# R&G (BD) Garment Ltd

Bhabanipur, Gazipur Sadar, Gazipur  
(24.147350585, 90.421449636)  
30 April 2023

# Observations

# Inconsistency in as-built drawing

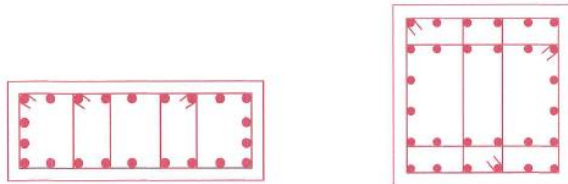
During inspection, mismatch found in column schedule of C5 column. As per provided as built drawing 22-20 mm re-bar shown in C5 column at ground floor, but in construction drawing 28-20 mm re-bar shown in C5 column at ground floor. Building engineer is required to survey the full building and update the as-built drawing accurately.

**Tested area not filled with specification**

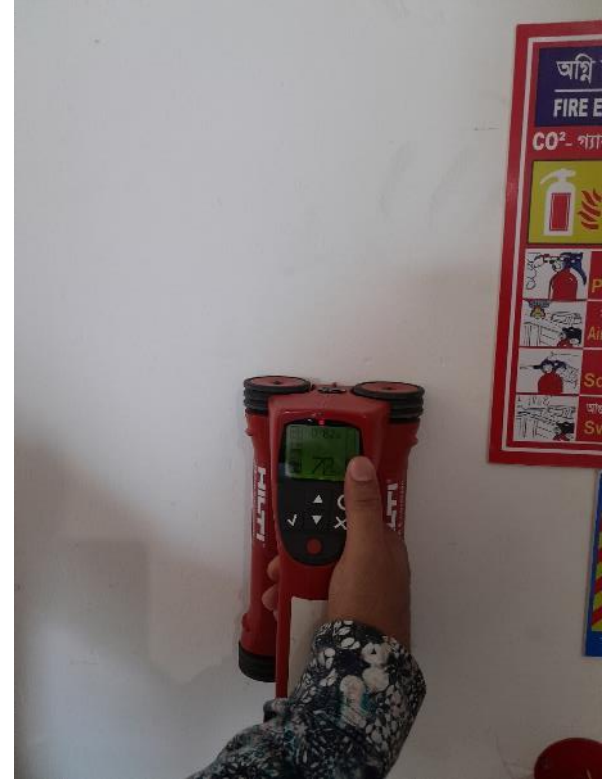
Tested areas found unfilled in all buildings.  
Building engineer is required to fill all the  
tested area by suitable method.
